# 7ELEVEN AT WALLBROOK (LOT 11)

## SITE DEVELOPMENT PLAN

**7ELEVEN AT WALLBROOK (LOT 11)**  
Town of Rolesville Project No. SDP 23-\_\_\_\_  
US 401 Business / S. Main Street & Virginia Water Drive  
Wake Forest Township, Town of Rolesville, Wake County, North Carolina

**Final Drawing - Issued for Permit Review Purposes Only**

**1**  
ELEVATION - FACING EAST  
3/16" = 1'-0"

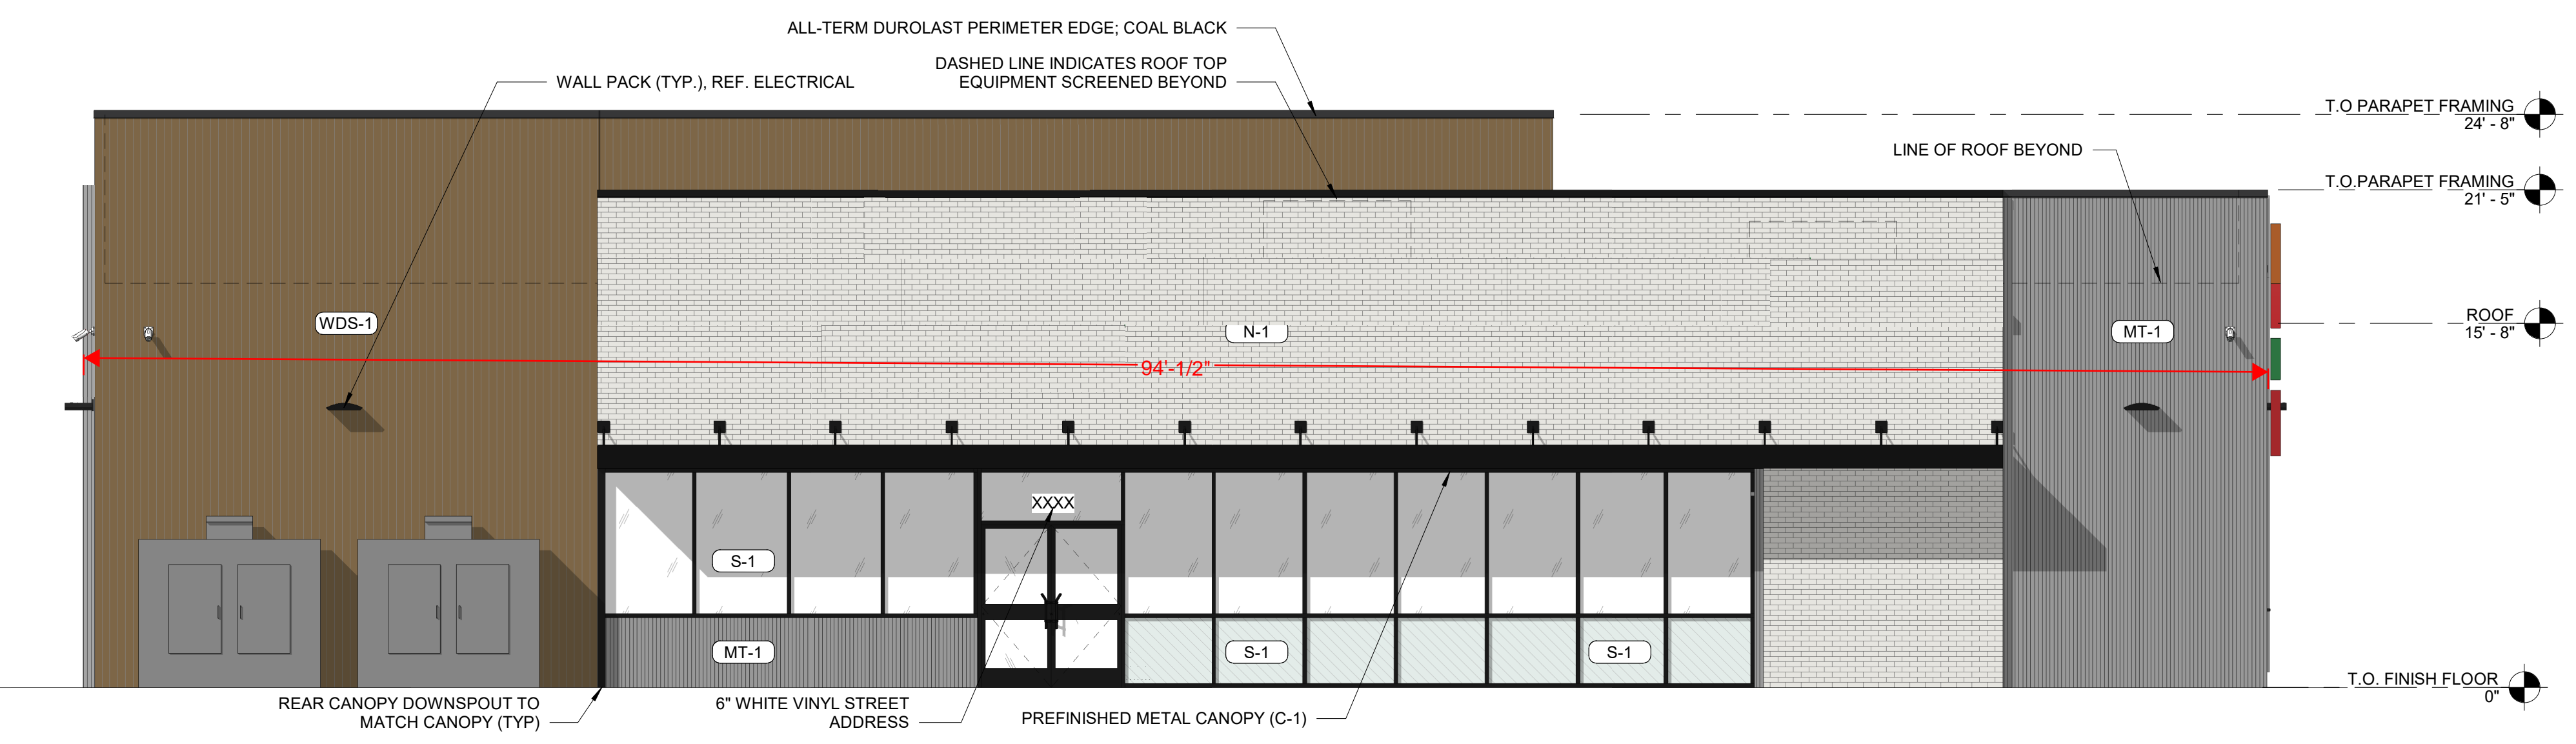
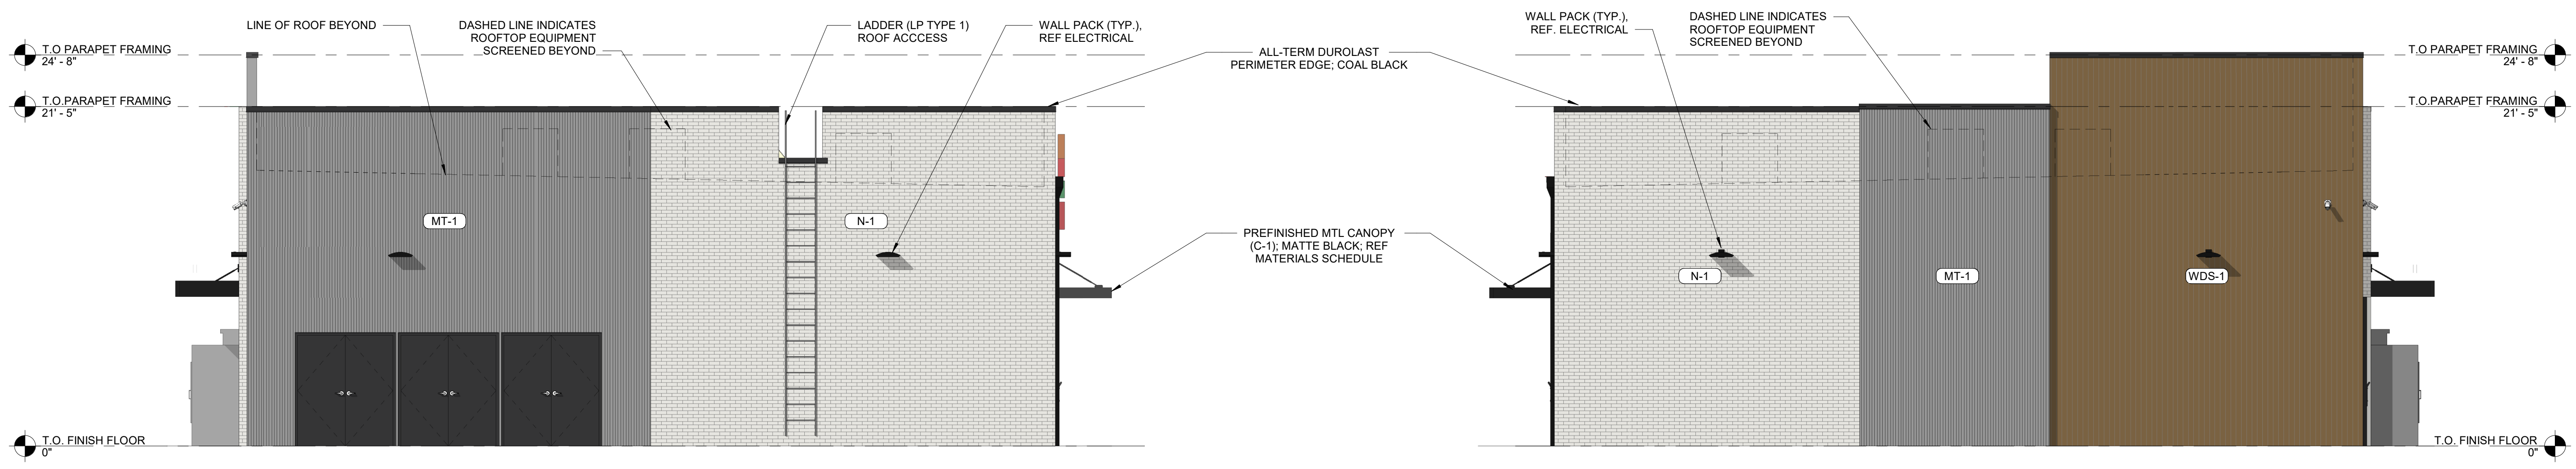
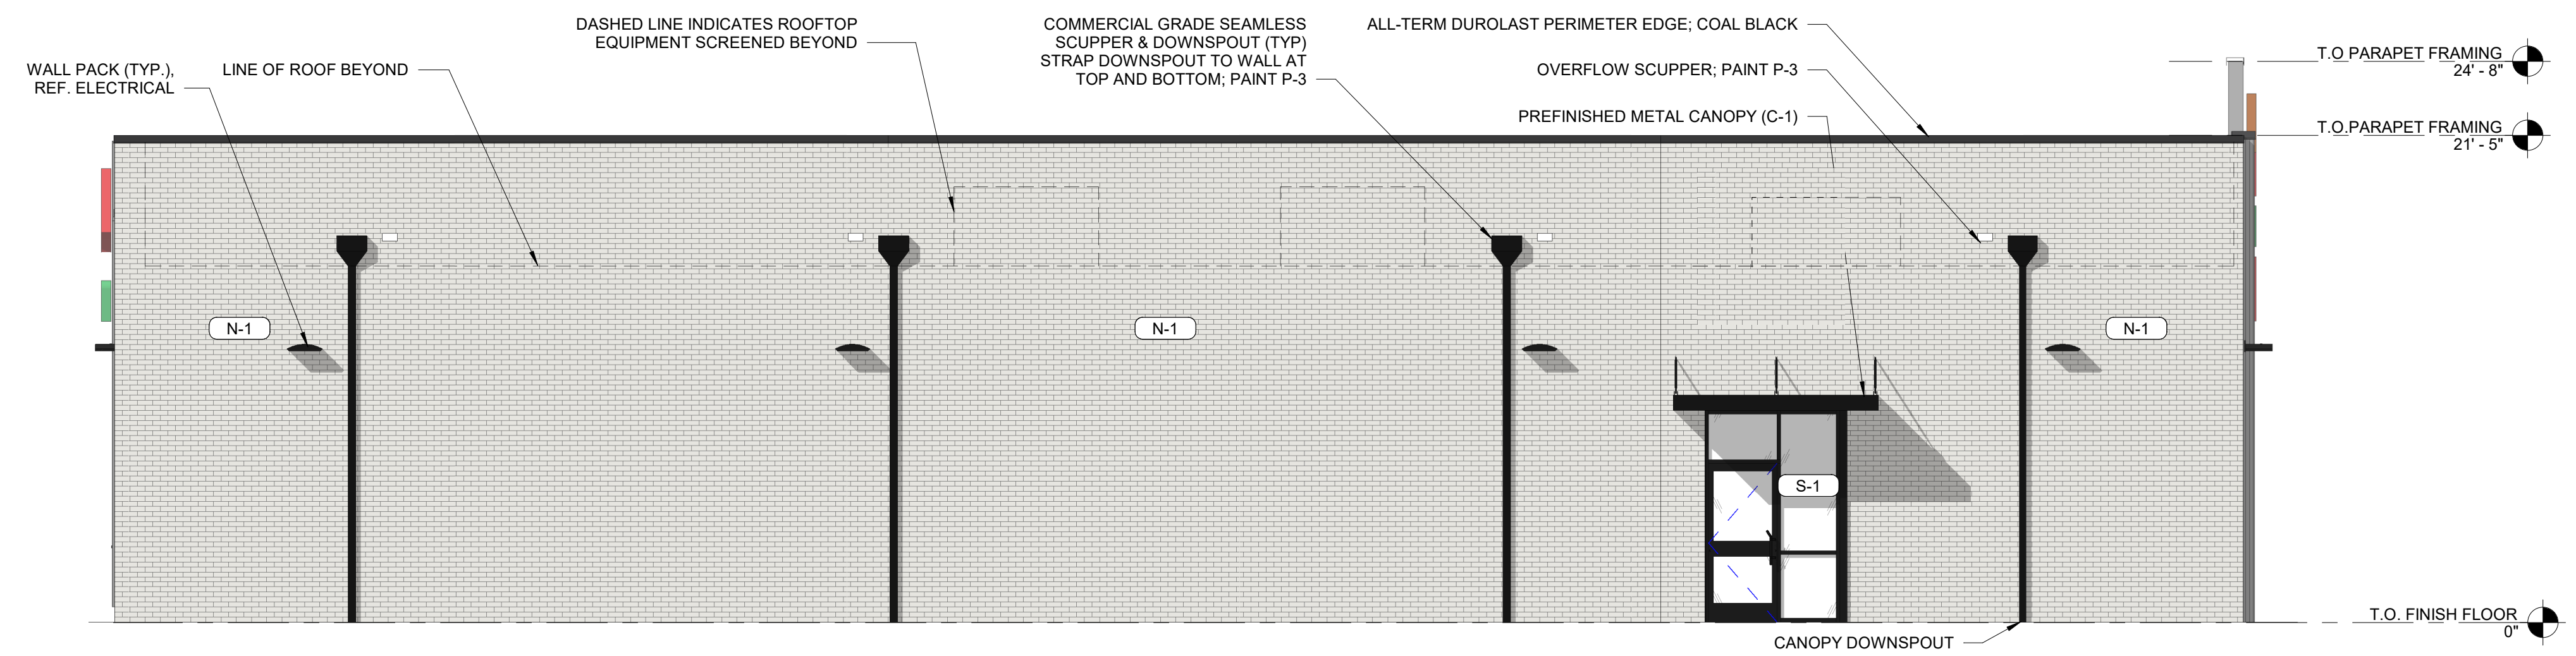
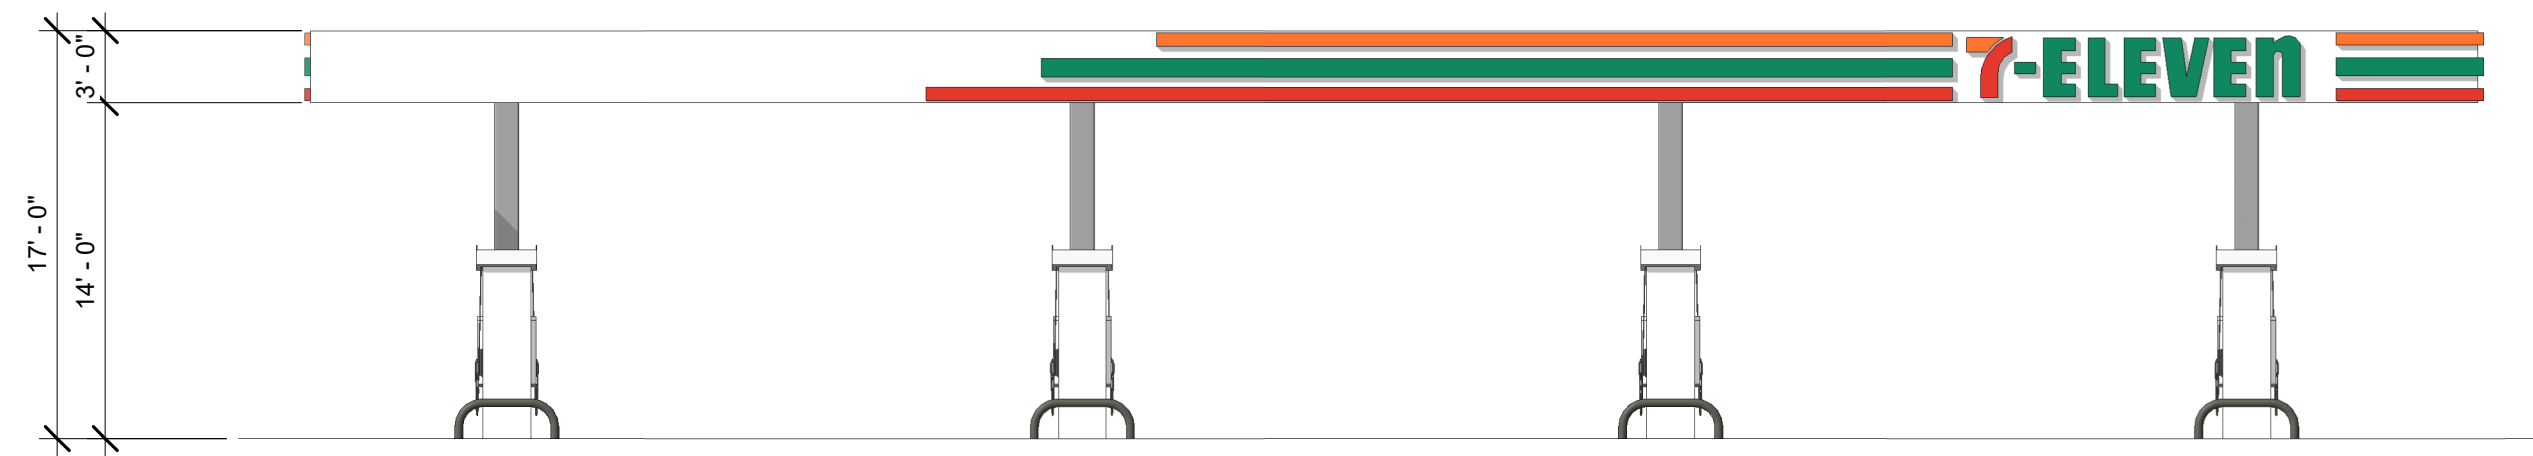
LDO Section 6.8.3.D.1.d notes that facades of 60 or greater feet in width shall incorporate wall offsets of at least one (1) foot of depth of every forty (40) feet. Illustrated as "D" in Figure 6.8.1.

Vinyl siding, smooth untreated concrete block, metal siding, faux stucco, and plastic materials are prohibited building materials.

Blank wall area is prohibited per LDO Section 6.8.2.C.1.
